Technical Service Bulletin

27 48V Vehicle electrical system warning, DTC P0CA700 and/or U046900 stored in the starter/generator control module/ECM

27 21 40 2058831/3 December 6, 2021. Supersedes Technical Service Bulletin Group 27 number 21-37 dated April 1, 2021 for reasons listed below.

Model(s)	Year	VIN Range	Vehicle-Specific Equipment
A6, S6, A7, S7, A8, and S8	2018 - 2021	All	48V MHEV

Figure 1. DTC U046900 with Expanded ambient condition “Starter generator, actual mode 48V” value of 5 in the engine control module (ECM), J623 (address word 0001).

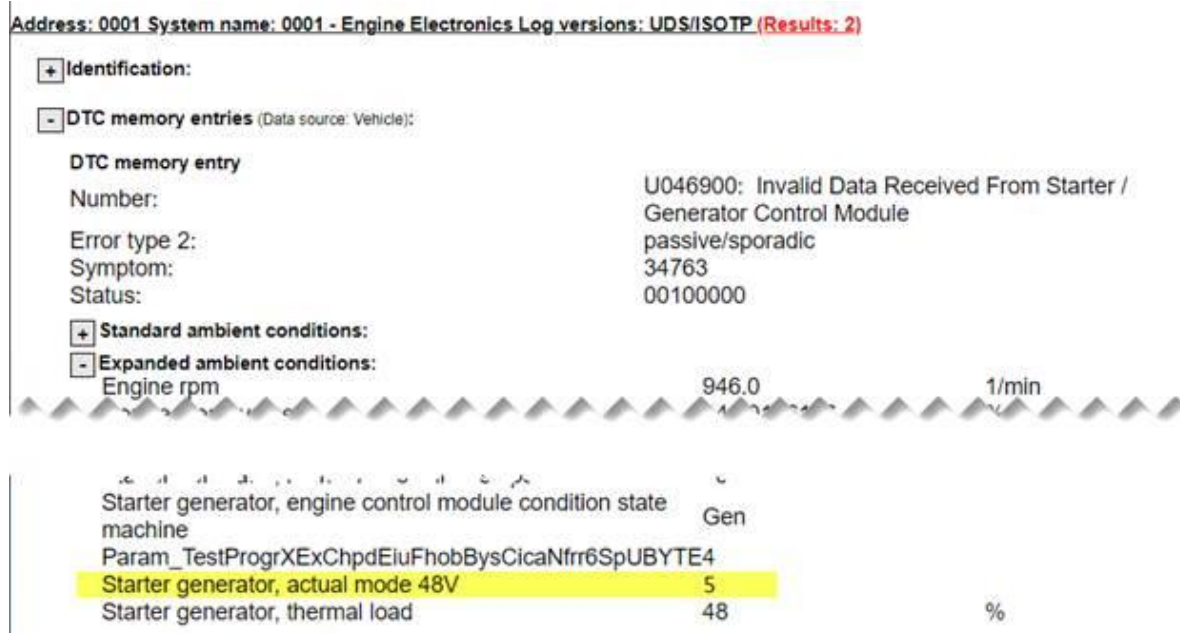
1. If DTC U046900 is found in the ECM, J623 (address word 0001), check the expanded ambient conditions of this DTC for the value of “Starter generator, actual mode 48V.”
2. If the expanded ambient conditions value for “Starter generator, actual mode 48V” is 5 (Figure 1) for DTC U046900, then replace the starter generator.
